PLAN 2 The Holly - RH 'GEORGIAN' ELEVATION

Lot 9 WS - 338 Yates Mill Drive, FUquay-Varina, NC 27526

10-5-23 - Initial Redline

11-14-23 - Revisions

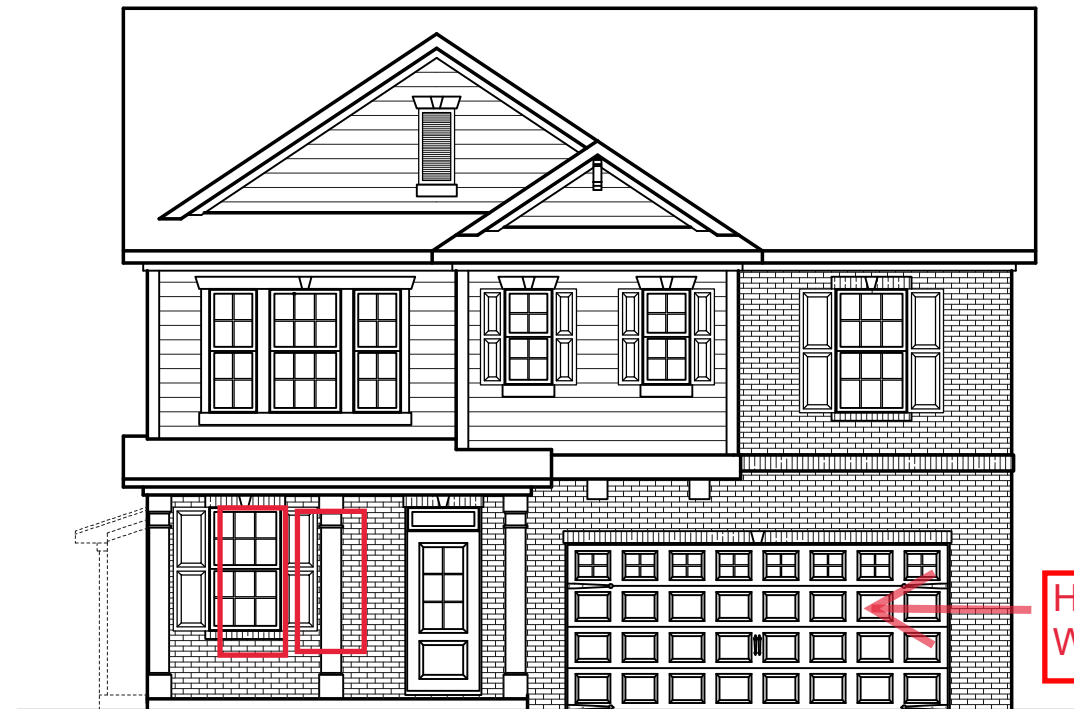
Black Windows

Hardware and Window Inserts

PLAN 2 - THE HOLLY - RH
Front & Rear Elevations 'Georgian' Crawl or Stem Wall

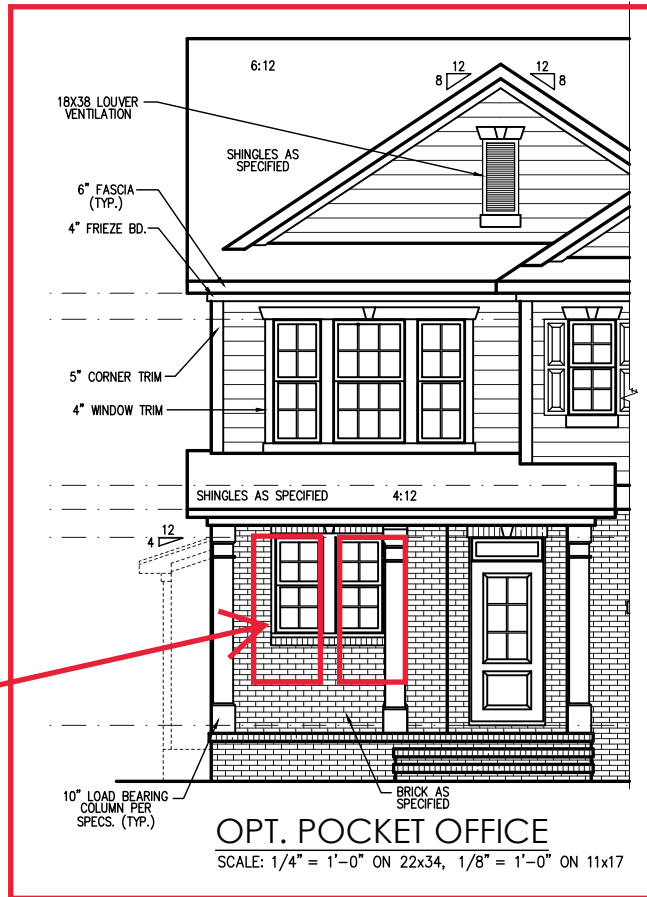
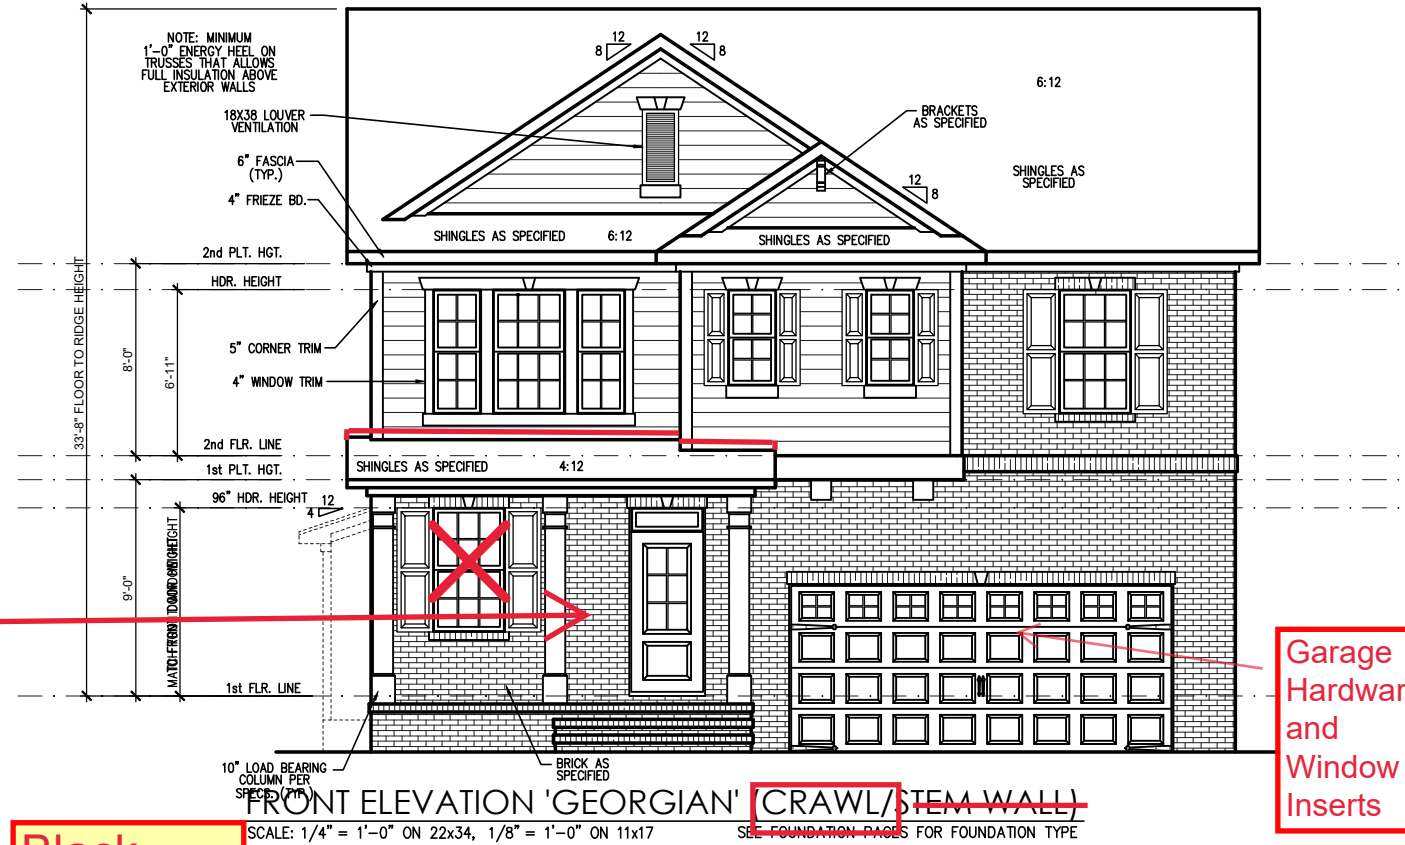
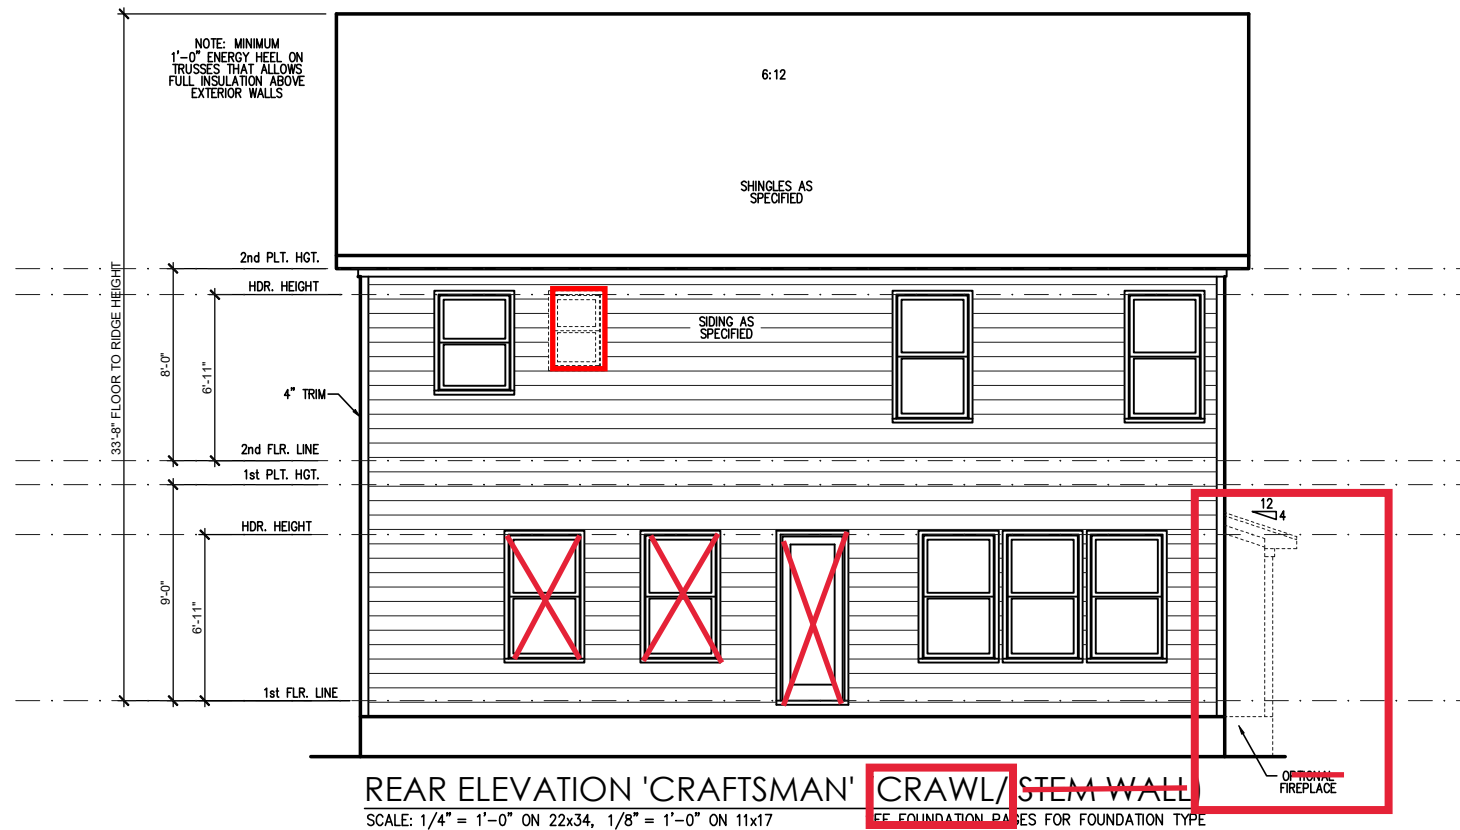
(2) 3/0x5/0 Window

Black Windows

Garage Hardware and Window Inserts
